Access Compliance Report

Public Rights-of-Way

(Curb Ramps)

Intersection ID: 17151	Main Street: E_INDEPENDENCE_BV	Cross Street: CONFERENCE_DR	Location: SW
ADA ID: 5675A70E6D50	Ramp Type: IslandPerp	Initial Pass/Fail: Fail	Overall Compliance: No
		Severity Score: 1.25

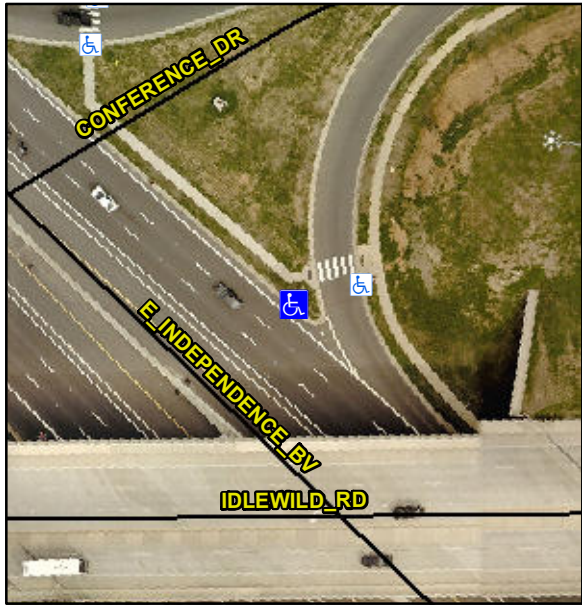
Codes/Mitigation Info/Possible Solution				Field Measurements/Component Compliance					
	Possible Solutions:			Compliance	Description	Data	Compliance	Description	Data
	Remove & Replace Entire Ramp.			N/A	Ramp Length (in)	66.0	Yes	Ramp Slope (%)	6.3
				Yes	Ramp Width (in)	59.0	No	Ramp XSlope (%)	3.4
				N/A	Flare Type LT	N/A	N/A	Flare Type RT	N/A
				N/A	Flare Slope LT (%)	N/A	N/A	Flare Slope RT (%)	N/A
				N/A	Flare Traversable LT?	N/A	N/A	Flare Traversable RT?	N/A
				N/A	Landing Length (in)	N/A	N/A	DWS Provided?	N/A
				N/A	Landing Width (in)	N/A	N/A	DWS Contrast?	N/A
				N/A	Landing Slope (%)	N/A	N/A	DWS Length (in)	N/A
				N/A	Landing X Slope (%)	N/A	N/A	DWS Full Width?	N/A
Surveyor Notes:			N/A	N/A	Landing Curb? (Y/N)	N/A	N/A	DWS Offset (in)	N/A
			N/A	Shared Landing?	N/A				
PROW/ADA:			N/A	N/A	Gutter Ponding?	N/A	N/A	Gutter Slope (%)	N/A
Not Found, R304.5.3			N/A	N/A	Gutter Lip Ht (in)	N/A	N/A	Gutter X Slope (%)	N/A

N/A	N/A	Painted X Walk1?	Yes	N/A	Painted X Walk2?	N/A
					X Walk 1 Direction	To E		X Walk 2 Direction	N/A
			N/A	N/A	X Walk 1 Width (in)	121.0	N/A	X Walk 2 Width (in)	N/A
					X Walk 1 Slope (%)	4.7		X Walk 2 Slope (%)	N/A
					X Walk 1 X Slope (%)	3.6		X Walk 2 X Slope (%)	N/A
			N/A	N/A	Ramp inside XWalk1?	Yes	N/A	Ramp inside XWalk2?	N/A
					Road Slope (%)	N/A	N/A	Clear Space?	N/A
					Road X Slope (%)	N/A	N/A	Clear Space to XWalk (in)	N/A
			N/A	N/A	Any Obstructions?	N/A	N/A	Storm Grate/Utility Hazard?	N/A
					Obstruction Type			Storm Grate/Utility Type	
						N/A			N/A
							Yes	Surface Condition? (G/P)	Good
Total Cost:			\$	3400.00
